# IMMINGHAM EASTERN RO-RO TERMINAL

Proposed Changes Notification Report

Document Reference 10.3.2

PINS Reference – TR0300072023

**Figure 2 – Proposed realignment of the Approach Jetty and related works**

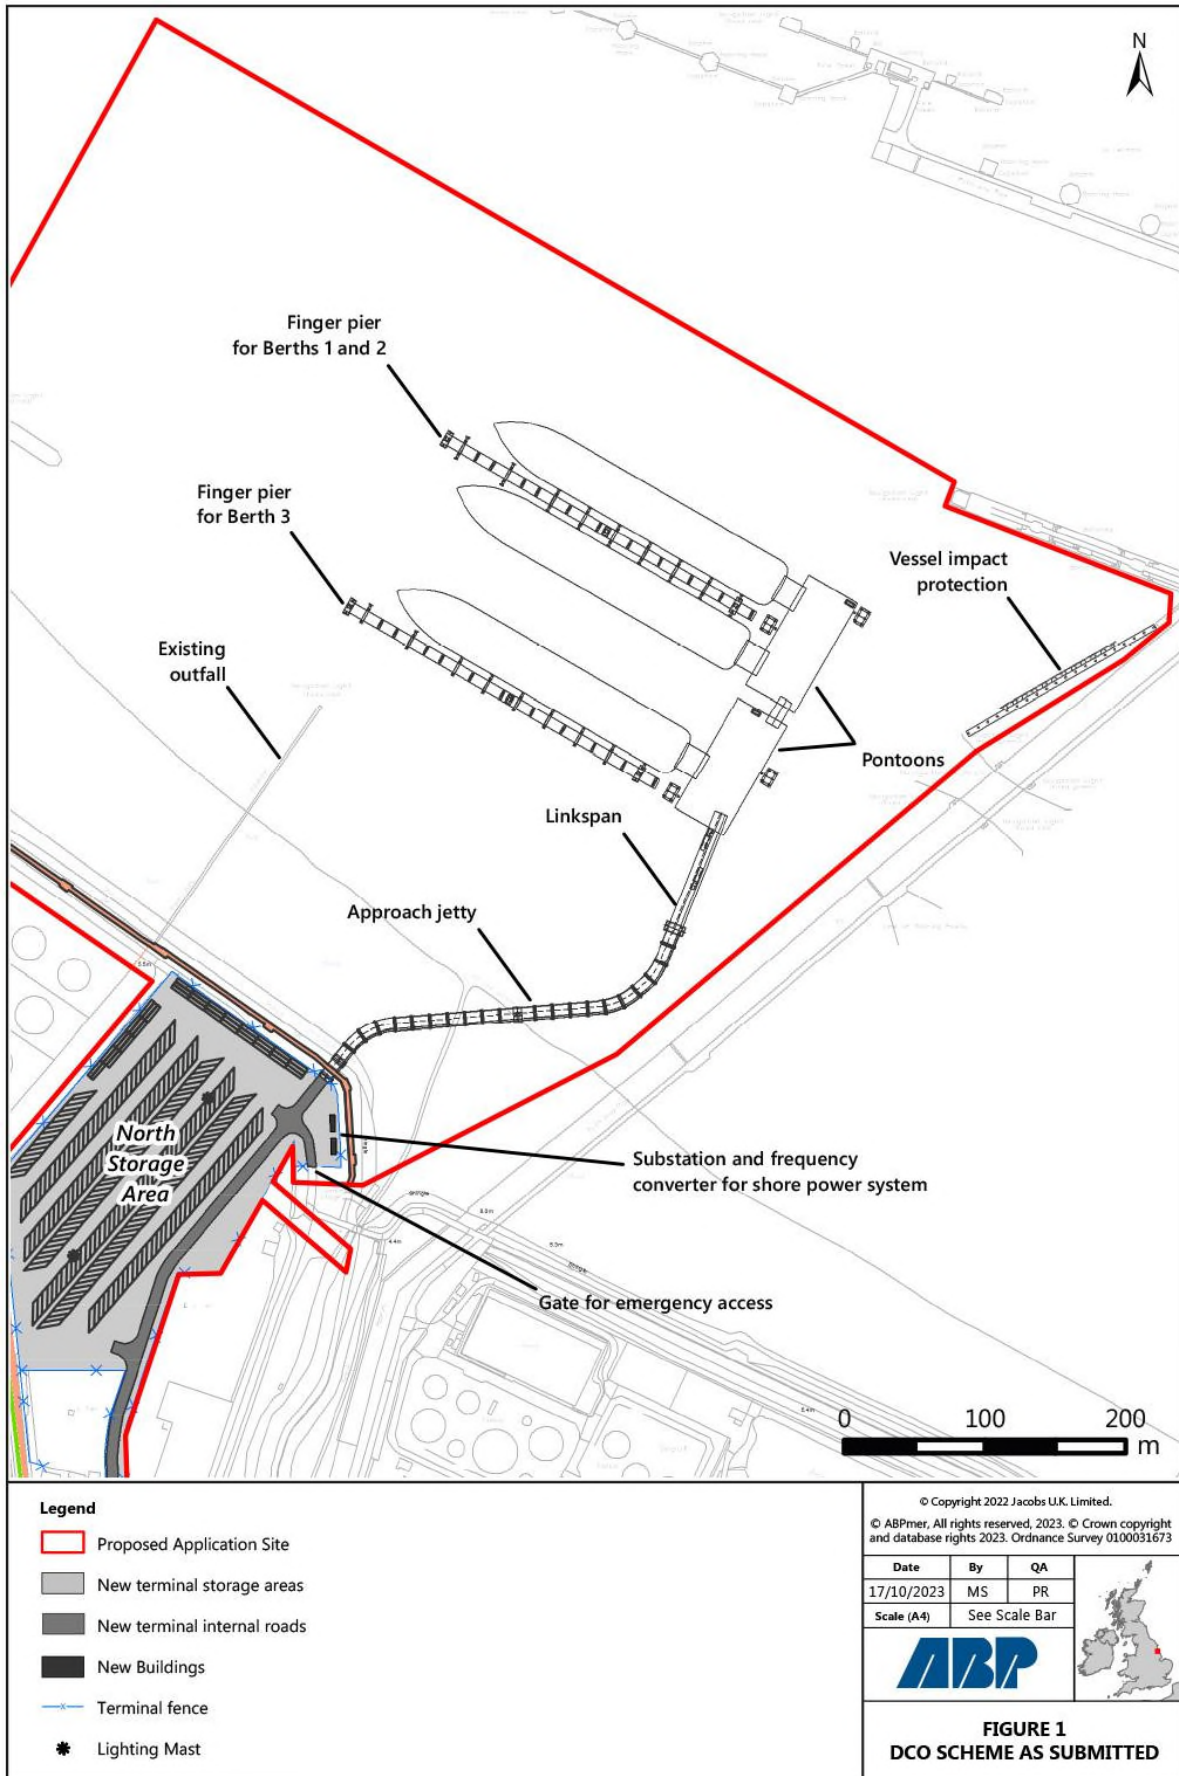
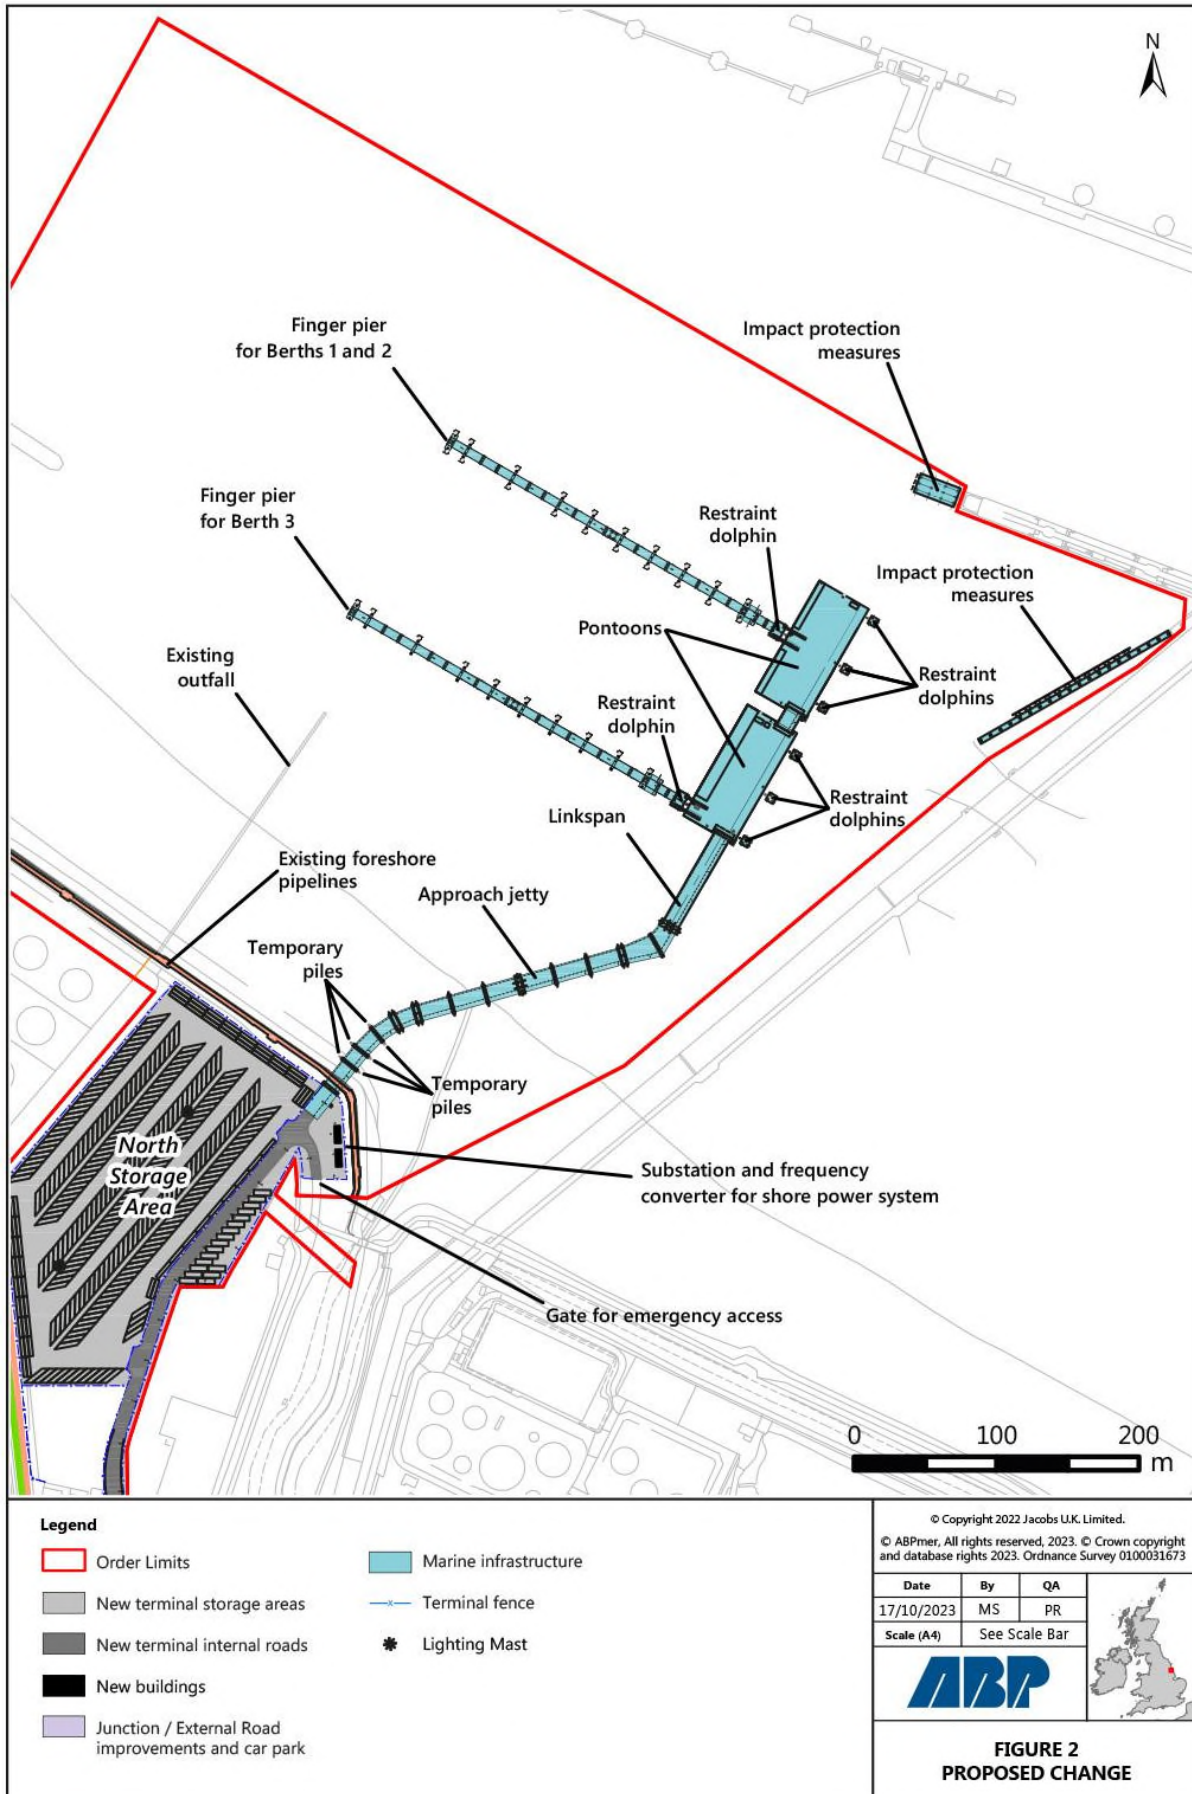
- 2.11 **Approach jetty** – the approach jetty has been straightened for efficiency from the alignment originally submitted, thereby accommodating an improved swept path for vehicular movement whilst at the same time moving the approach jetty away from IOT marine infrastructure. The realignment has also facilitated a repositioning of some of the piles leading to a slight reduction in the number of piles used.

- 2.12 **Bridging of foreshore pipelines** – at the interface between the landside and the approach jetty, the jetty structure has been raised from the design originally submitted to enable ease of access/inspection of the pipes running under the new jetty.

- 2.13 **Restraint dolphins** – up to two additional restraint dolphins are proposed for each of the landing pontoons to improve stability. The environmental effect of the increase in the number of piles required for the restraint dolphins has been assessed as minimal – this is outlined in the ES Addendum (Appendix 1) at paragraphs 7.2.3 - 7.2.8 and 9.2.6 - 9.2.9.

- 2.14 **Finger pier adjustments** – two additional piles to support bollards above, have been added to the Proposed Development's finger piers to improve mooring performance. In addition, the platforms serving both finger piers have been enlarged to facilitate the provision of the shore to ship power equipment. The additional piling required has been assessed to identify whether there is likely to be a change to the conclusions on environmental impact set out in the ES. The conclusion is that any additional impact will be minimal – as detailed in the ES Addendum (Appendix 1) at paragraphs 9.2.6 - 9.2.9.

- 2.15 Figures 1 and 2 below show how the originally submitted scheme would be amended if this proposed Change 1 is accepted.

3.3 The amended design will move the approach jetty some 31 metres further away from the Immingham Oil Terminal trunkway at its closest point (from 38 metres as originally proposed in the DCO application to 69 metres).

- a) the grouping of the piled rigid frames;
  - b) the reduction in jetty length; and
  - c) the increased length of the deck sections (25 metres in length as opposed to sections of 12.5 metres as originally proposed) –
- will help to reduce the construction programme by approximately two months.

Figure 4 – Line of the proposed realigned and shortened Internal Link Bridge

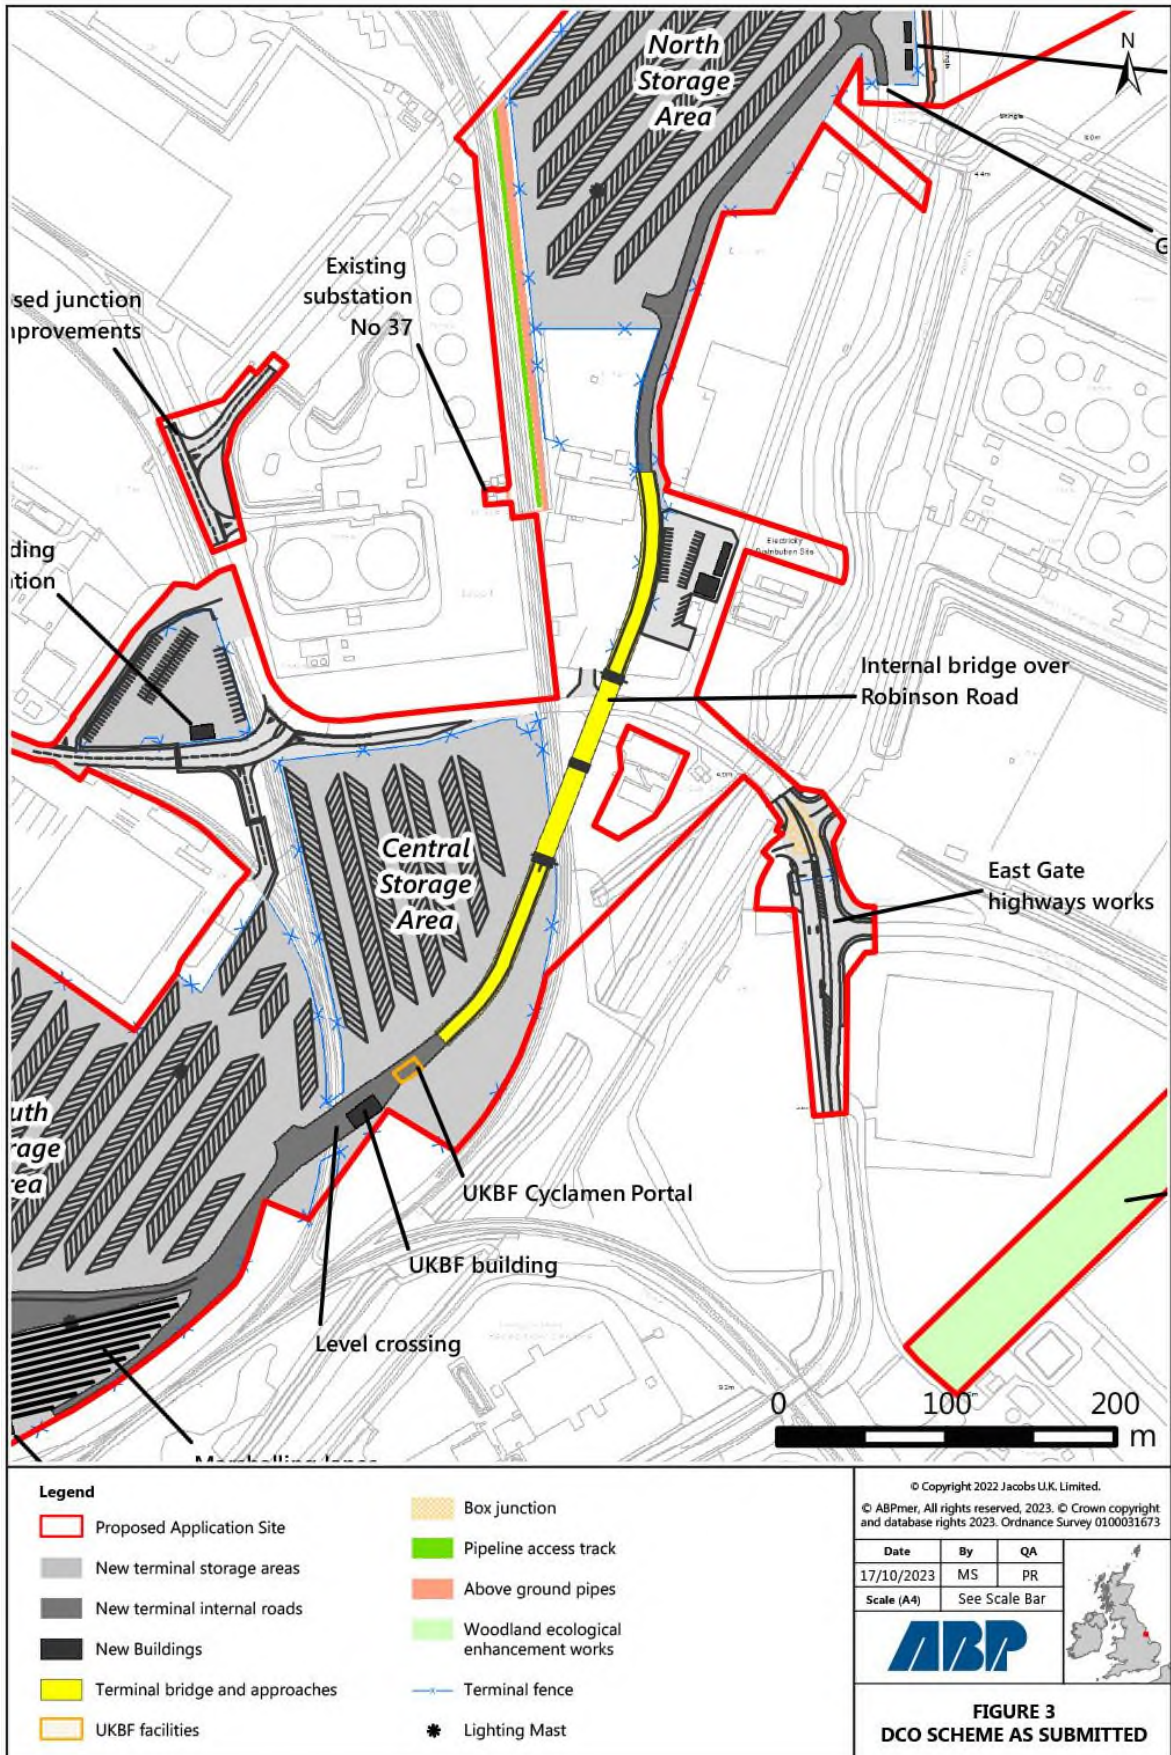
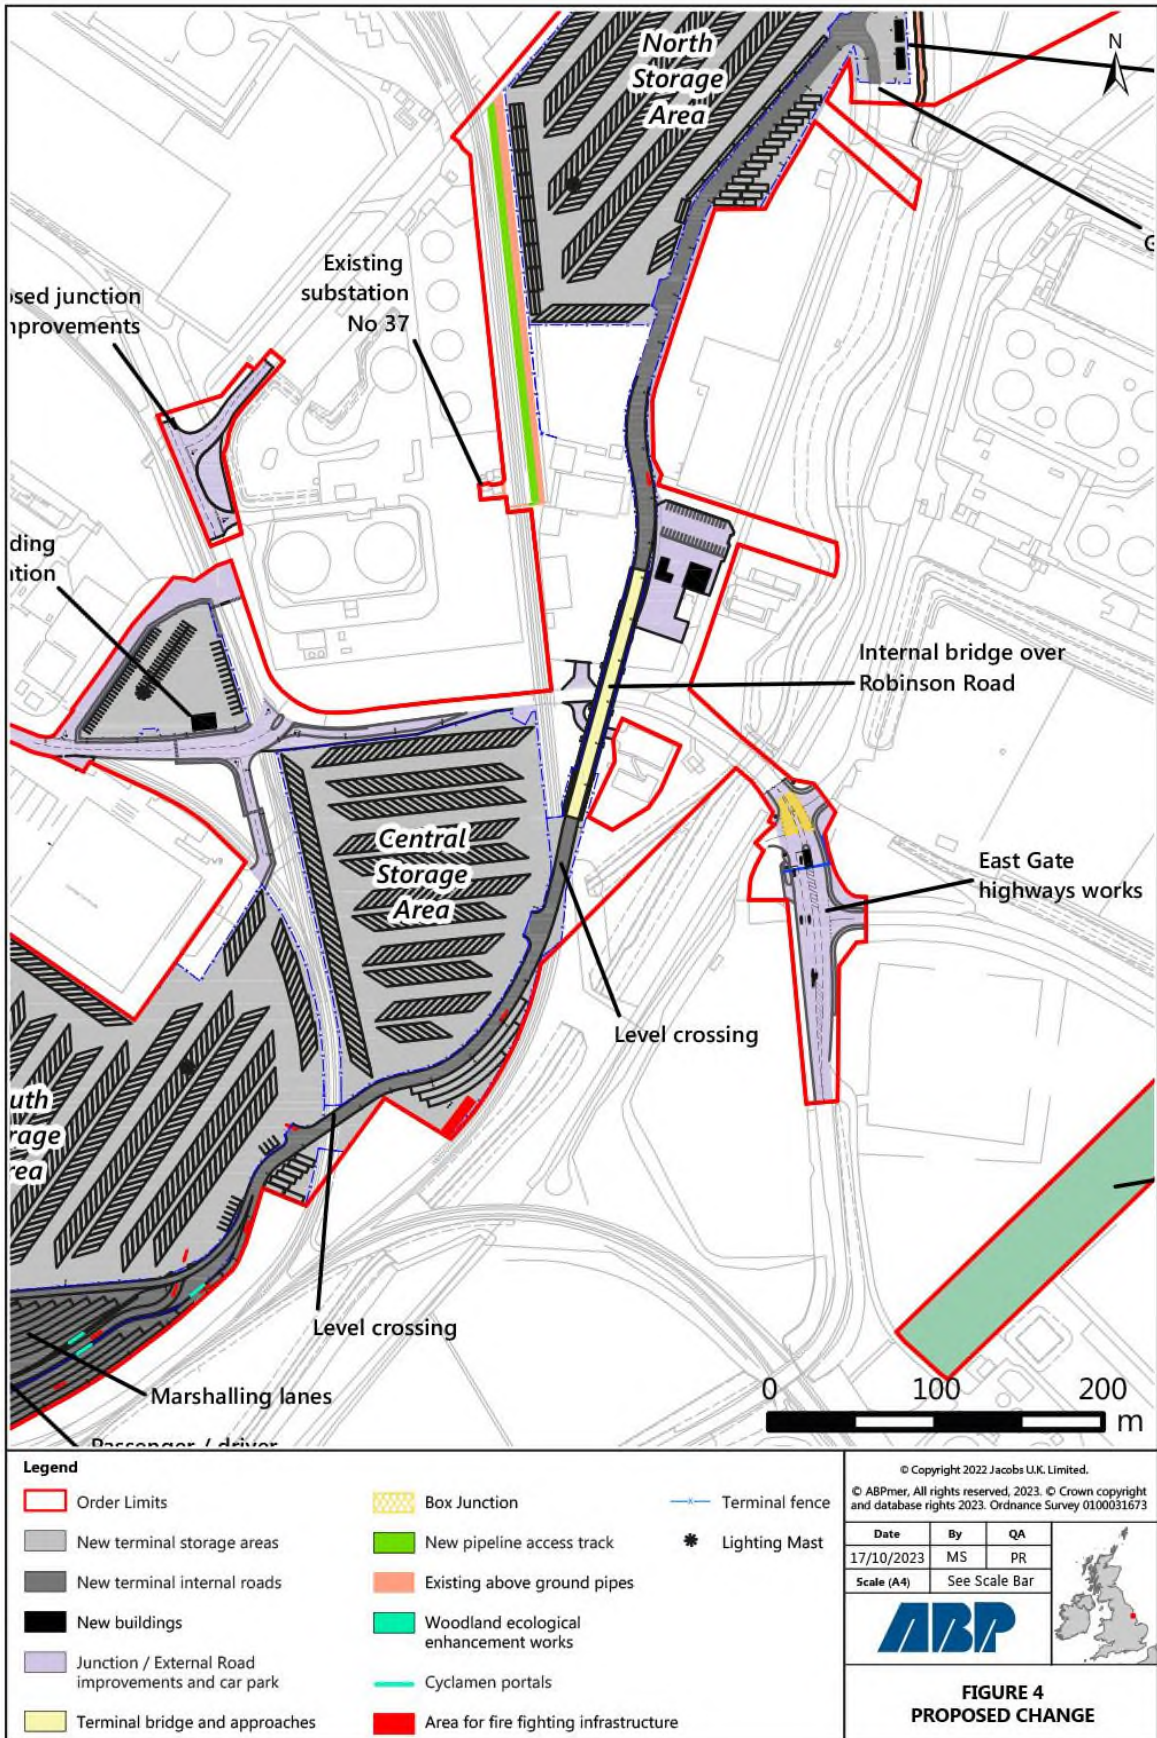
- 2.19 The proposals as submitted as part of the February 2023 DCO application would have taken the southern line of the bridge across the ABP internal railway line and some distance into the Central Storage Area. By shortening the length of the bridge an area of land within the Central Storage Area previously not available for use can be brought into use.

- 2.20 The change affects the originally submitted plans in that to bring the bridge down safely before ABP's internal railway line, it will be necessary to amend the originally identified limits of deviation.

- 2.21 Figures 3 and 4 below show how the originally submitted scheme would be amended if this proposed Change 2 is accepted. Further details are provided in the ES Addendum (Appendix 1) at paragraph 2.3.

- 3.11 The shortened bridge, at its northern end, will still cross over the internal port road, Robinson Road, but will then cross the ABP controlled railway line at ground level by means of an ABP controlled level crossing – although it should be noted that this railway line is in fact rarely used – beyond which access will be gained to the Central Storage Area.

- 3.12 In order to bring the roadway to ground level before reaching the level crossing, it has also been necessary to refine the ramp length without imposing excessive gradients that might compromise safety.

- 3.13 As noted above, the shortening of the bridge has led to a need to make a slight adjustment to the line of the bridge, which has led to the need to alter the originally defined limits of deviation.
